Appl. No. 10/770,926
Amdt. dated October 25, 2005
Reply to Office Action of July 26, 2005

Amendments to the Drawings:

FIG. 2

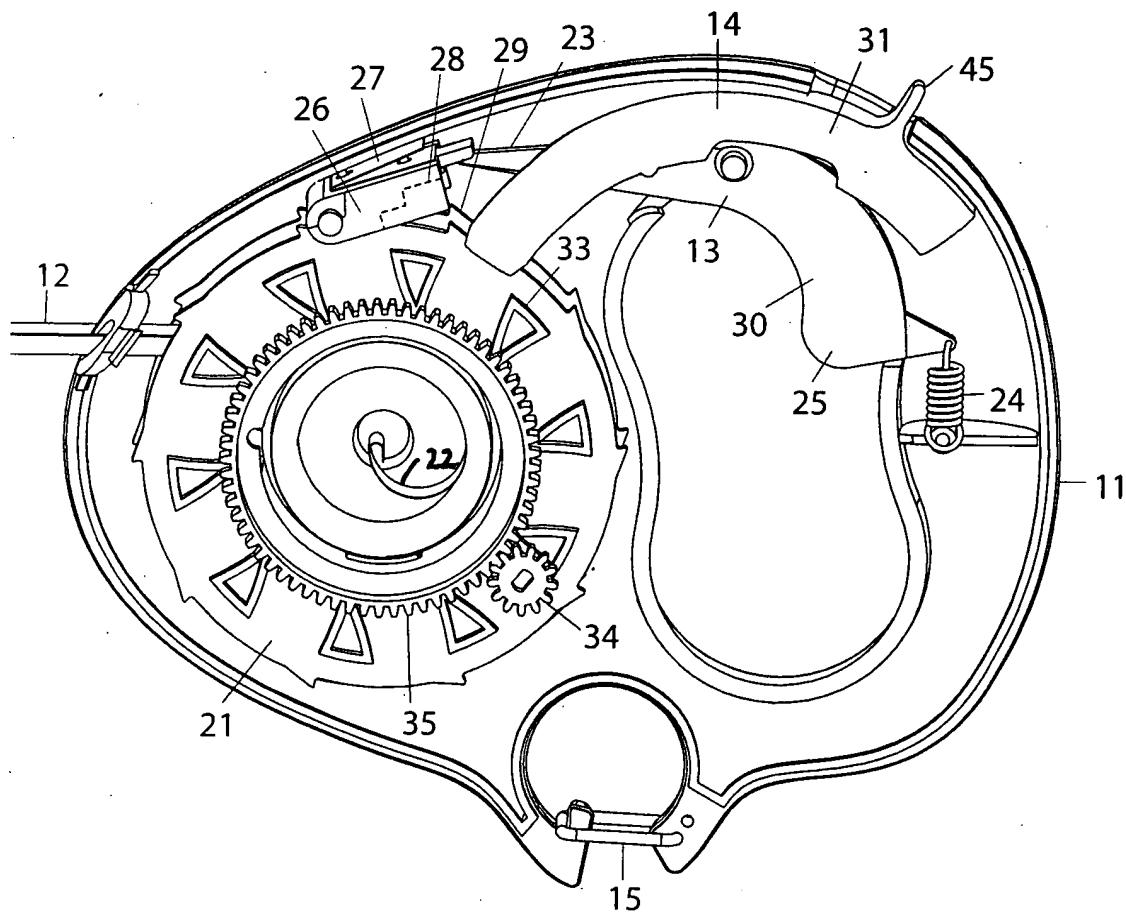
As required by the Official Action, included in the amendment are an "Annotated Sheet Showing Changes" and a "Replacement Sheet" for Fig. 2. In Fig. 2 the reference numeral "22" has been added for the spring which biases reel 21 as described at page 5, line 17 of the specification.
